## Change Order Request

**Project:** 1923025-02  
La Crosse Center Expansion & Renovation  
400 La Crosse Street  
La Crosse, WI 54601

**COR #** 194.00

Proposal Request Number: 026  
REVISED-2

**OFFICE LEVEL AND MEETING LEVEL PLANS**

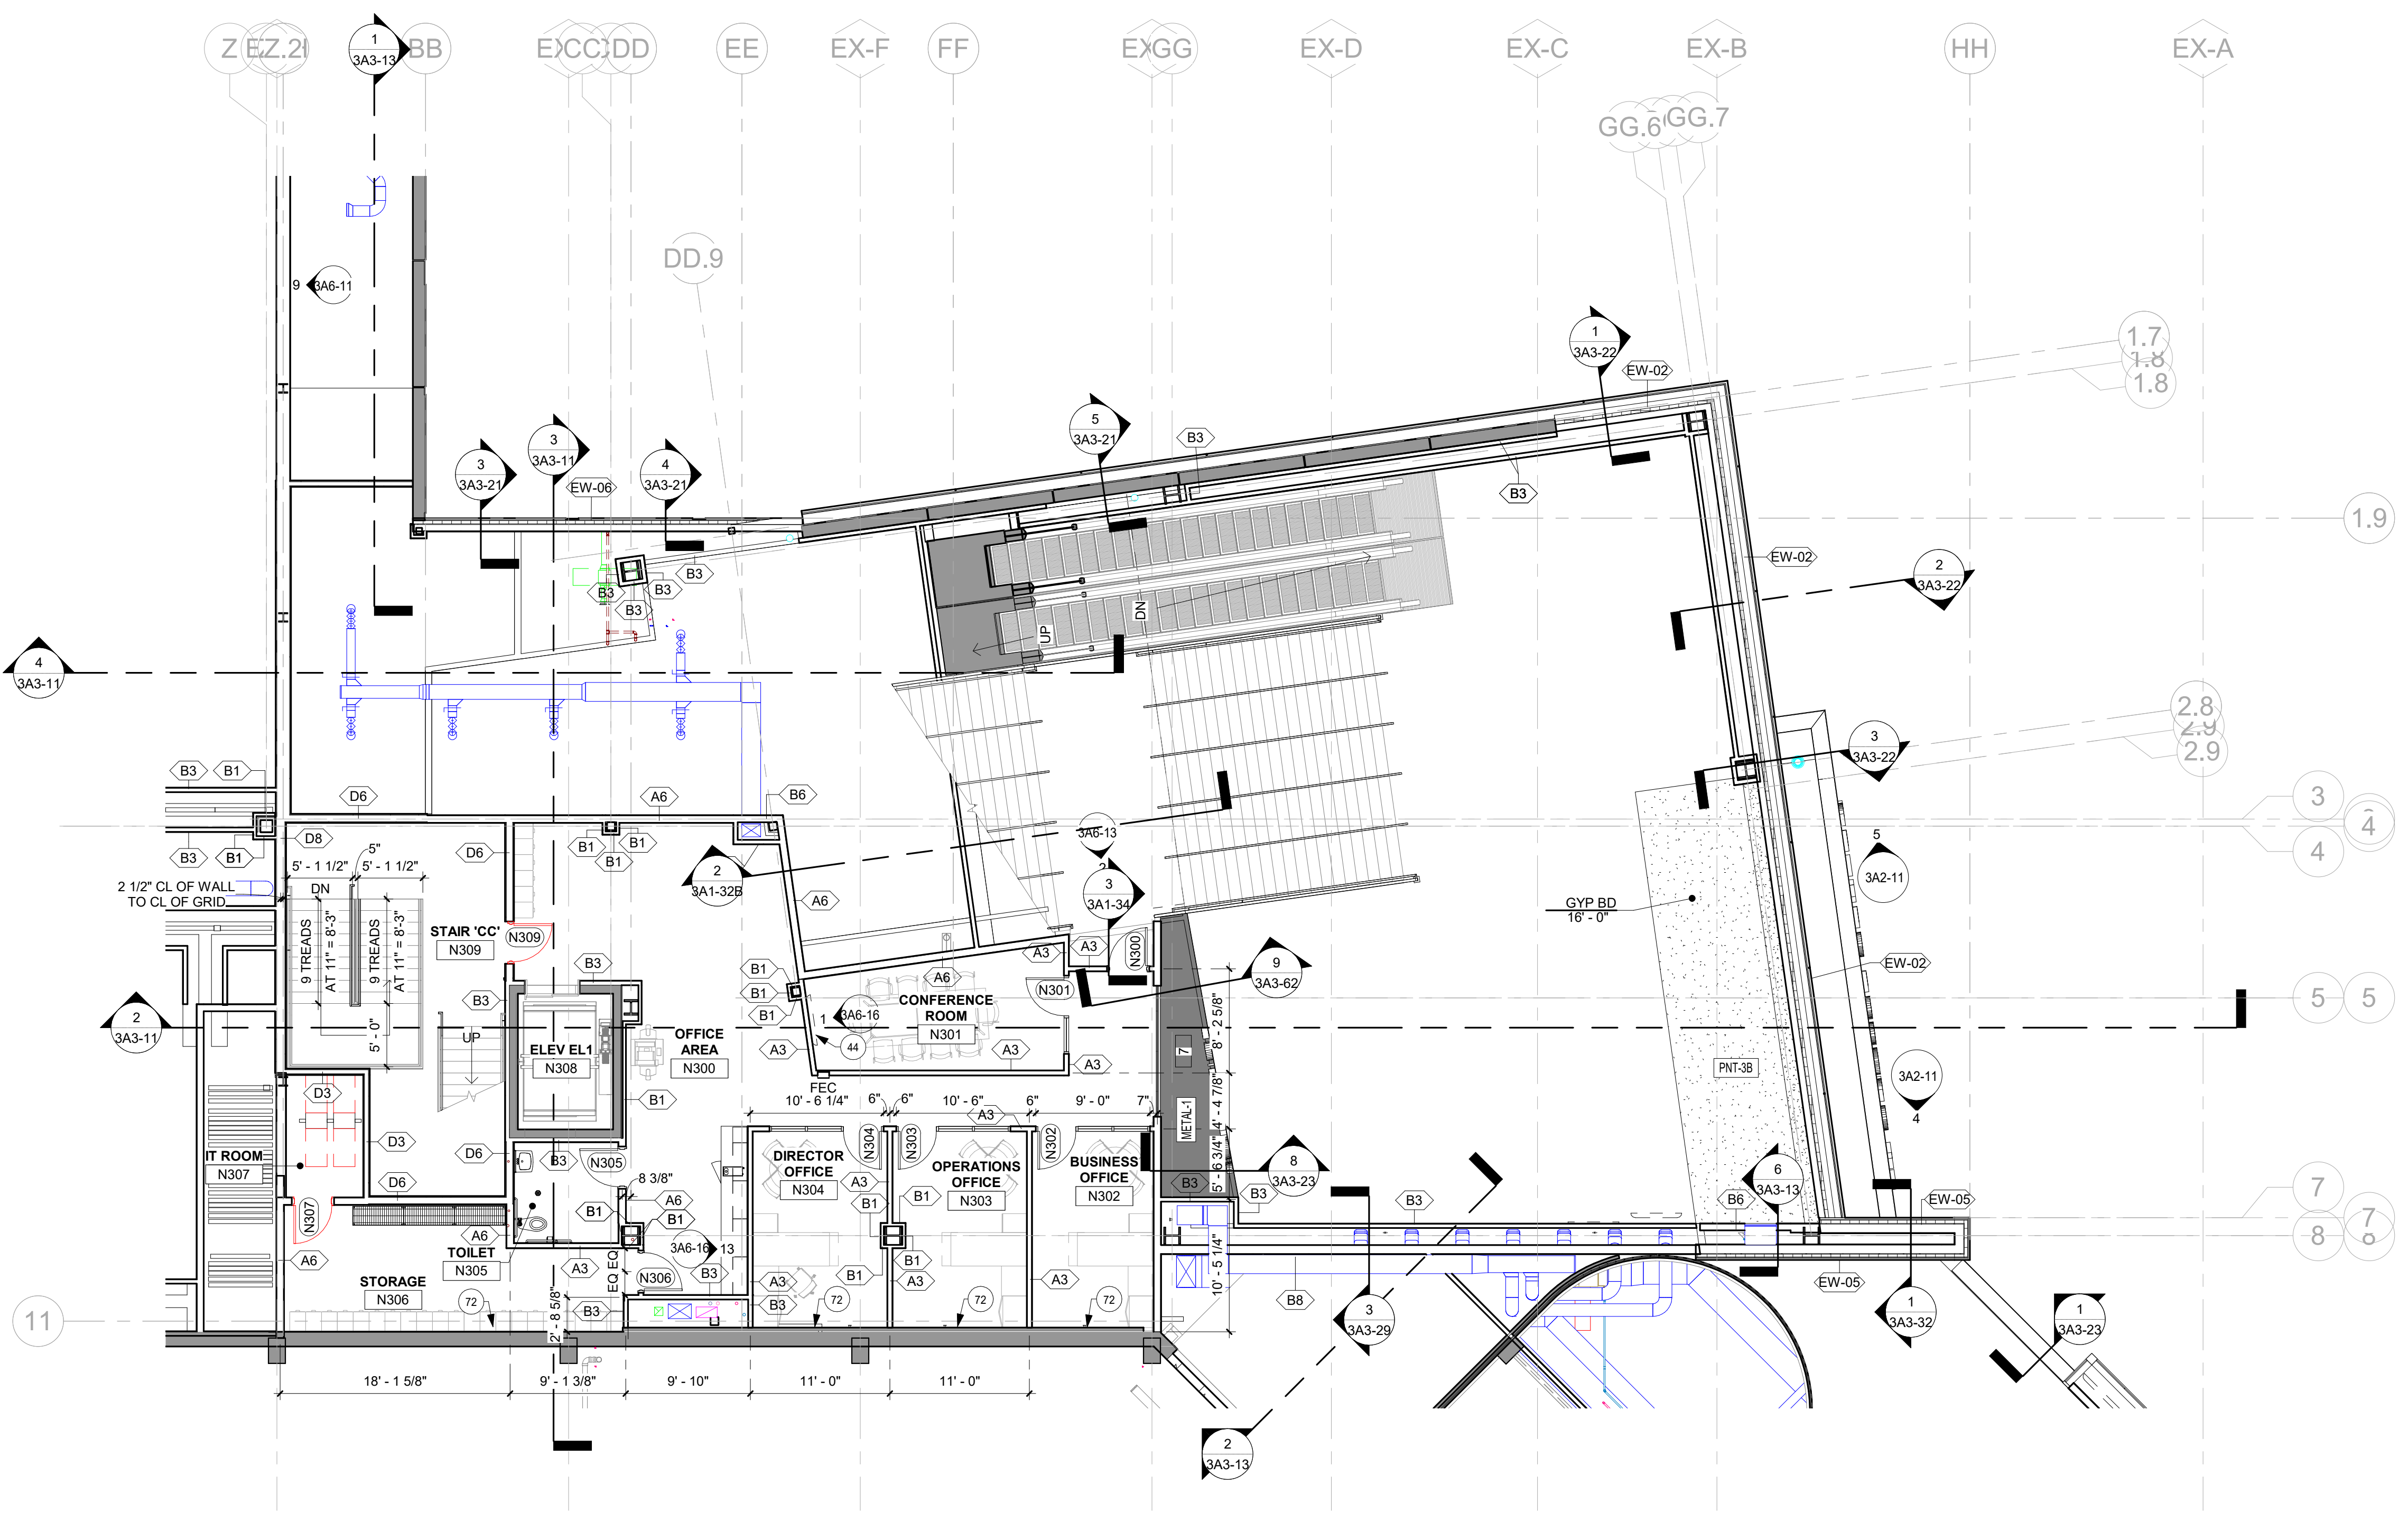
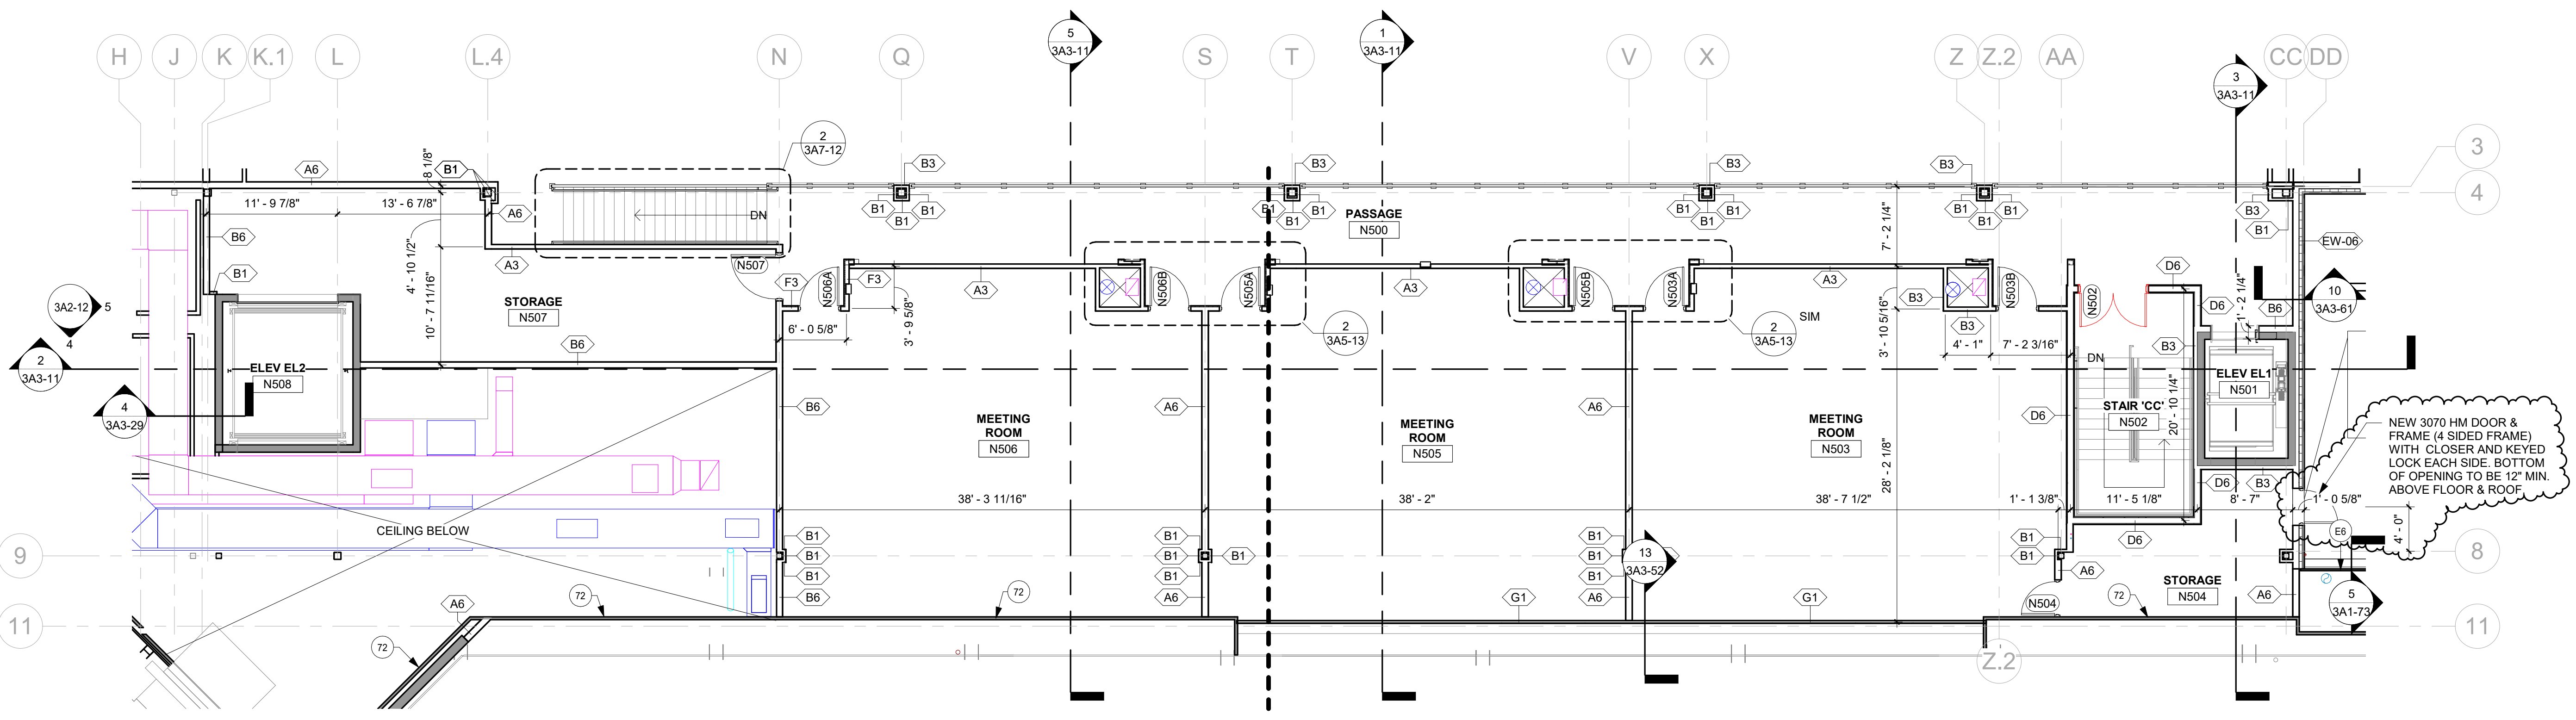
- Item 1: Refer to Revised Plan Sheet 3A1-24  
a. Add exterior door from ballroom level to entrance hall roof
- Item 2: Refer to Revised Plan Sheet 3A1-71

SHEET **3A1-71**

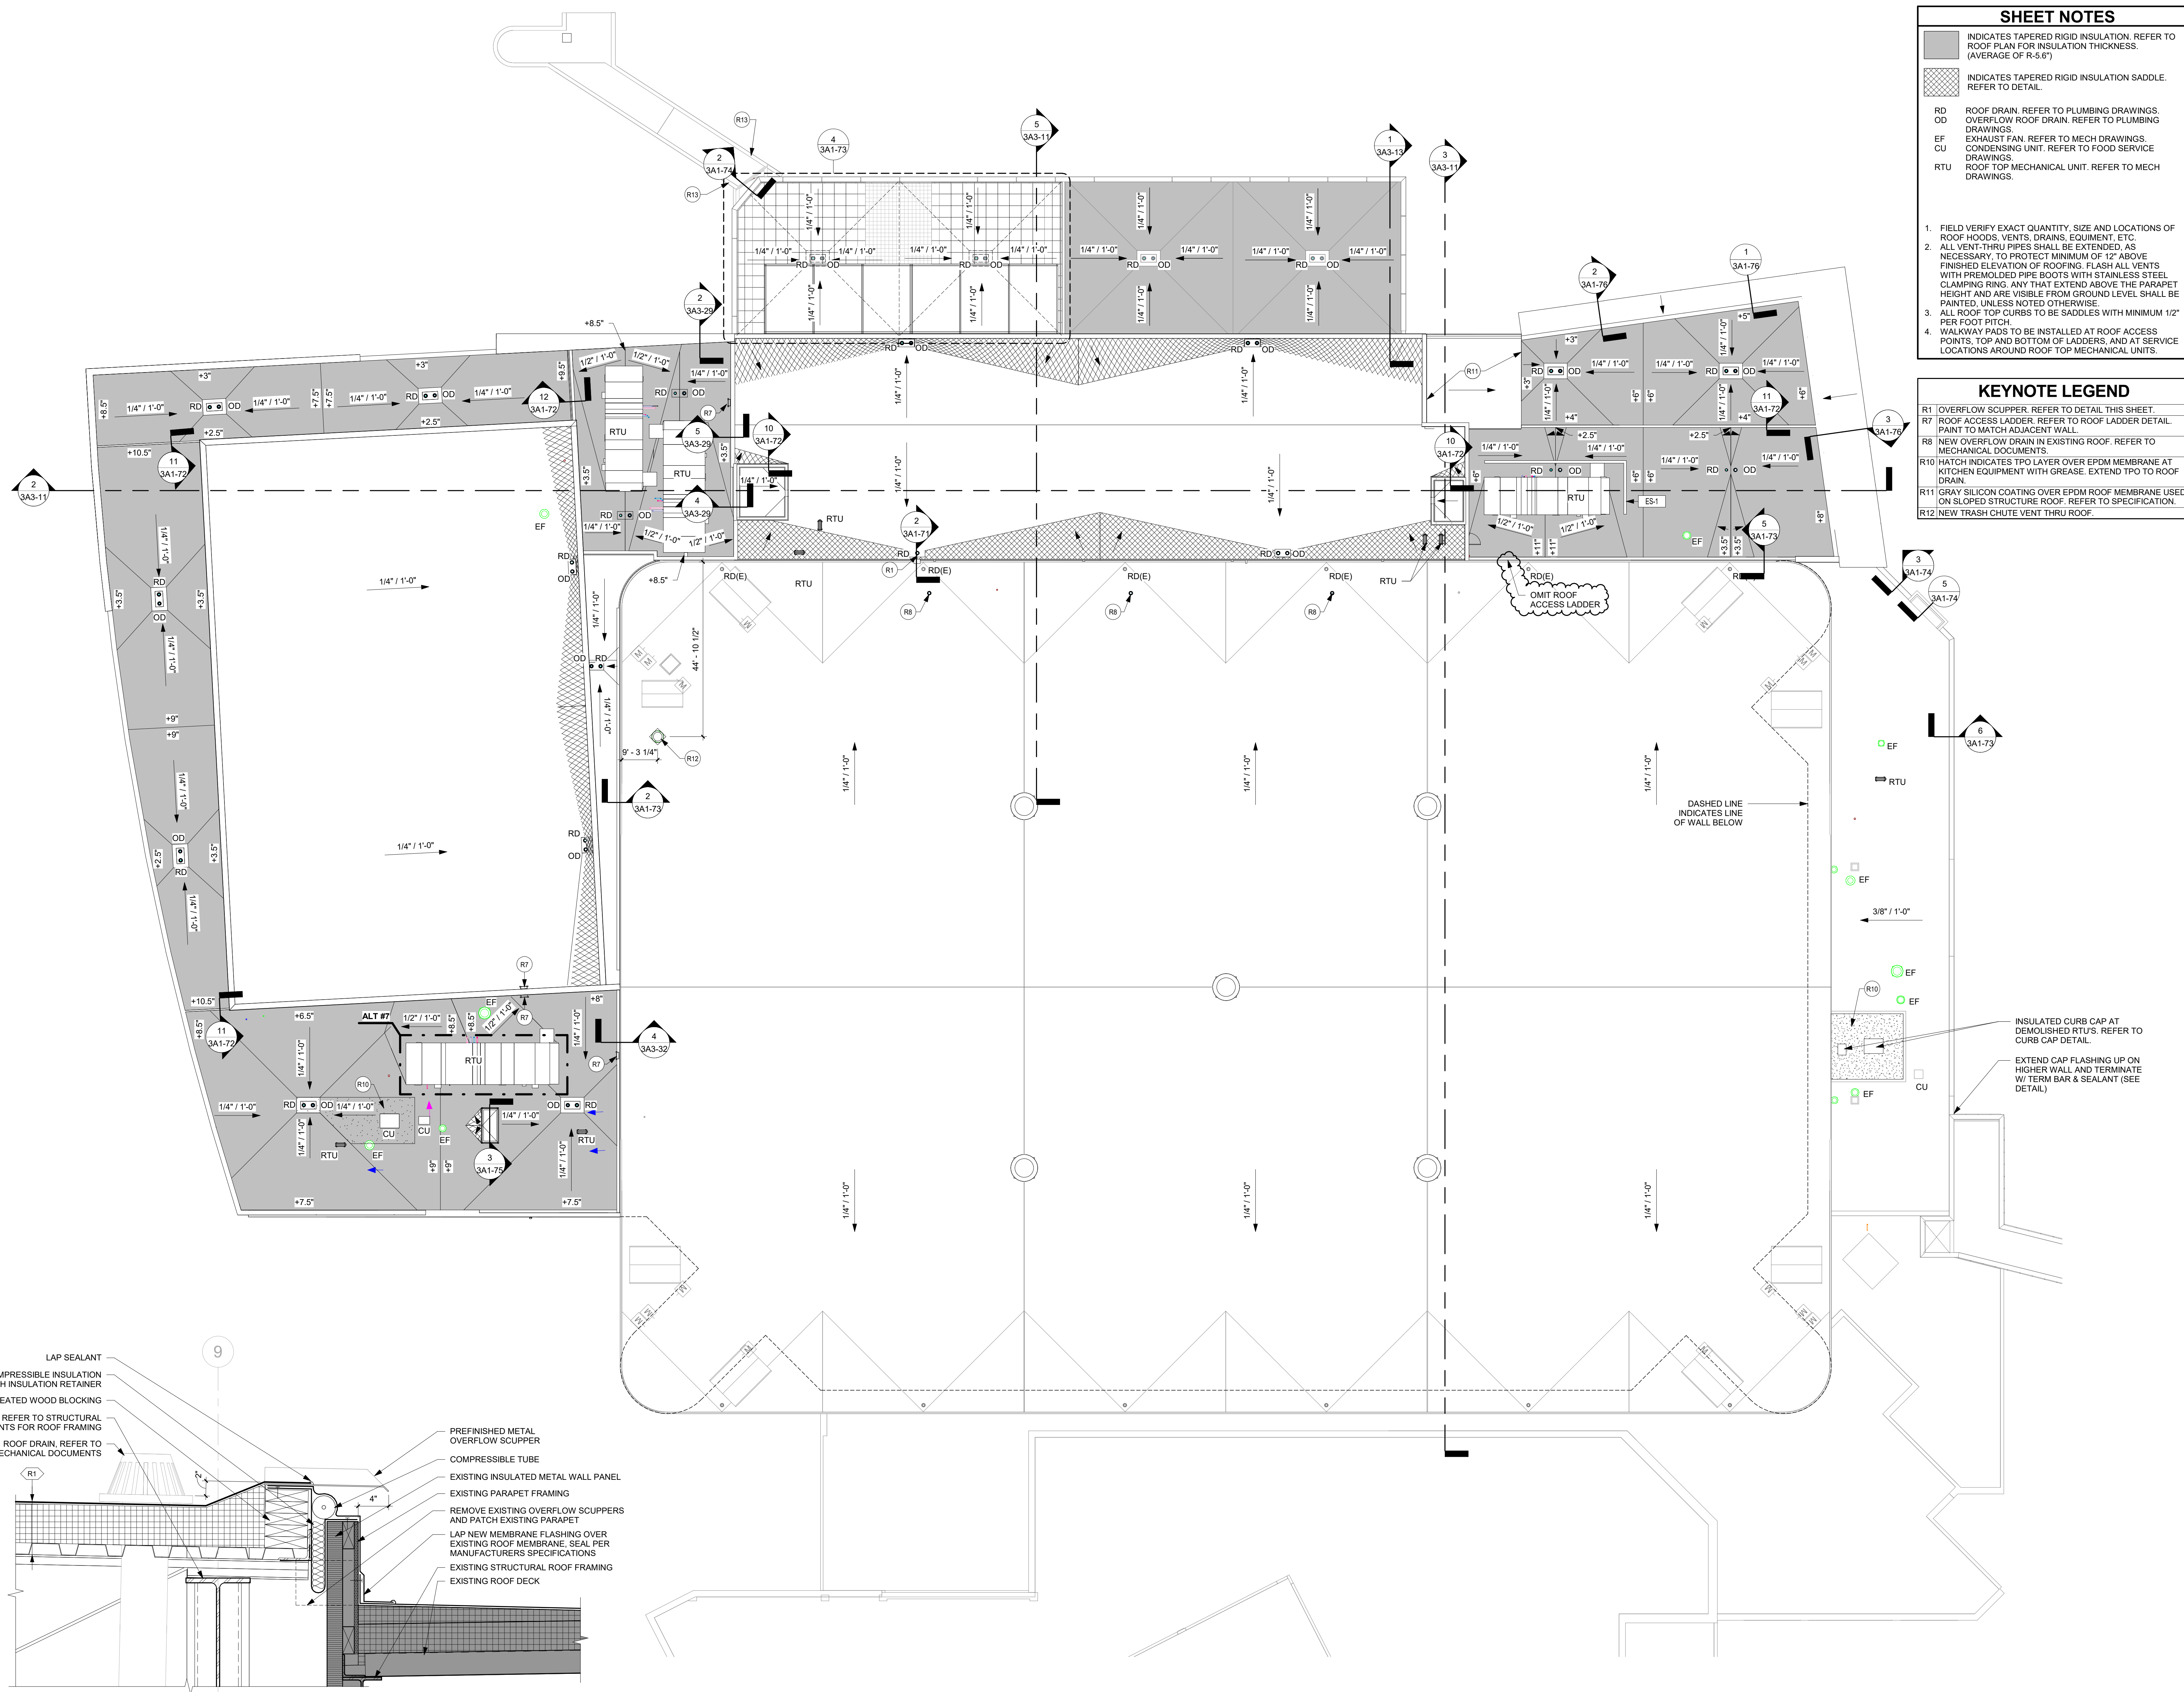
a. Remove roof access ladder from arena roof down to entrance hall roof
- Item 3: Refer to Revised Plan Sheet 3M2-10A – ARENA LEVEL HVAC PLAN – AREA A
